PCN-20210129 CR00140-02 Kit SoM Update

Company	Trenz Electronic GmbH
PCN Number	PCN-20210129
Title	CR00140-02 Kit SoM Update
Subject	BOM change
Issue Date	2021-01-29

#2 Change SoM from TE0720-03-1CFA to TE0720-03-61C33FA

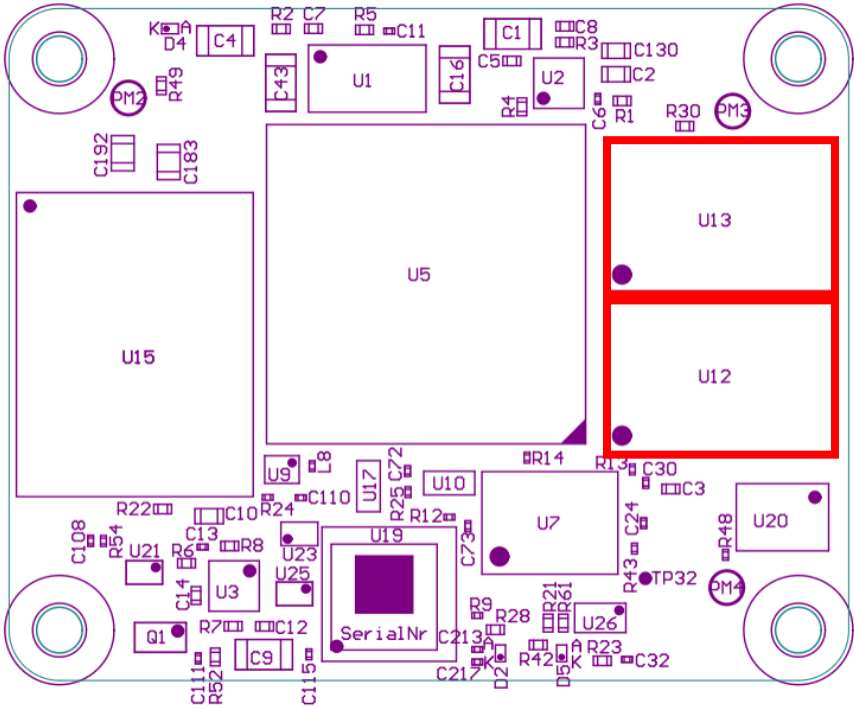
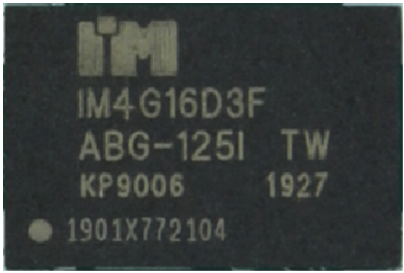
Impact: DDR3, Flash and eMMC of SoM are changed. For exact changes and impact see [PCN-20210126a TE0720-03 DDR3, Flash, EMMC Change and Product Update \(Revised\)](#).

As mentioned in [PCN-20210126a TE0720-03 DDR3, Flash, EMMC Change and Product Update \(Revised\)](#) the most prominent change for identification is the DDR3 RAM of the SoM. Locate DDR3 RAM (U12, U13) at top side of PCB:

old	new
IM4G16D3FABG-125I	IS43TR16256BL-125KBLI
